Change in Transmission Front Suspension

The change effects all vehicles after identification No. (chassis No.):

Coupe	110 407
Cabriolet/Hardtop	153 023
Roadster	87 492

Fig. 1

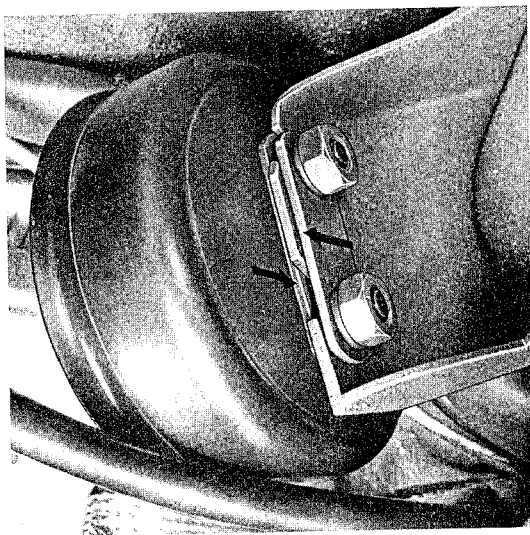
Beginning with transmission No. 35 001 a gear box cover with two support brackets is used, which connects the transmission by way of two rubber cushions to the rear suspension tube. The torque rod of the centrally supported transmission is no longer required and is omitted.

The installation of the transmission is accomplished in the same sequence as in section R, operation 1 RA, observing the following points in particular:

1. Before installation the two rubber mounts with sockets must be installed on the brackets of the gear box cover.
2. When engaging the transmission supports into the mounts on the body, note that the body section lies between the two clamping plates.

Fig. 2

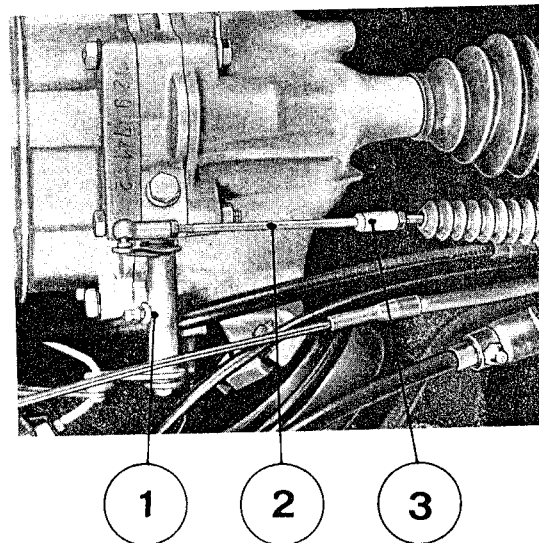
The throttle cable bell crank has been mounted on the bearing plate (intermediate plate) instead of the cover. For this reason an extension is required between the cable and bell crank.
